SERVICE BULLETIN

DATE: 8 DECEMBER 1978

INSPECTION AND REWORK OF TAIL ROTOR HUB, PN 369A1725 AND 369A1725-5; INSPECTION OF TAIL ROTOR BLADE ATTACHMENT BOLTS, PN MS21250-06040

Figure 1. Rework of Tail Rotor Hub Assembly

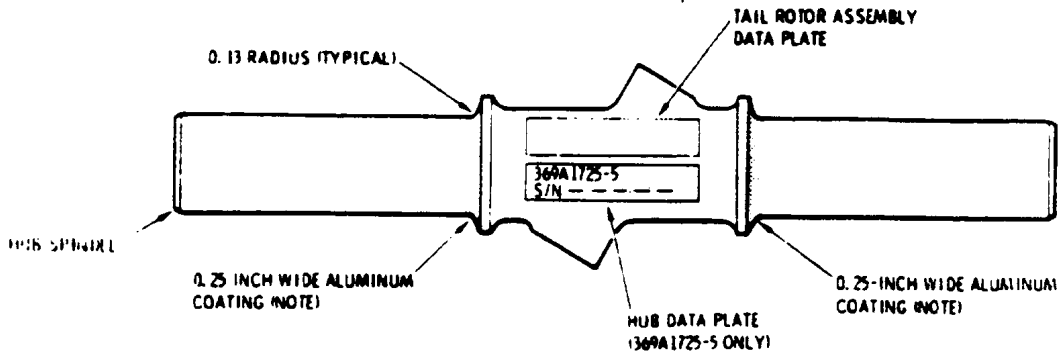
(3). Using 10X glass, inspect hub for cracks, corrosion or other damage. Pay particular attention to area of 0.13 radii between the spindles and center portion of the hub. (See Figure 1.)

(b). Brush a thin (0.0002 to 0.0005 inch) even coat onto cleaned surface of 0.13 radius areas on both sides of hub. (See Figure 1.) Limit width of aluminum coating to 0.25 inch to prevent contact with feathering bearings.

(6). To denote rework of 369A1725-5 hub, add letter "Z" following serial number on hub data plate; to denote rework of 369A1725 hub, add letter "Z" following part number on tail rotor assembly data plate. (See Figure 1.)

NOTE:
LIMIT WIDTH OF ALUMINUM COATING
TO 0.25-INCH TO PREVENT CONTACT
WITH FEATHERING BEARINGS.
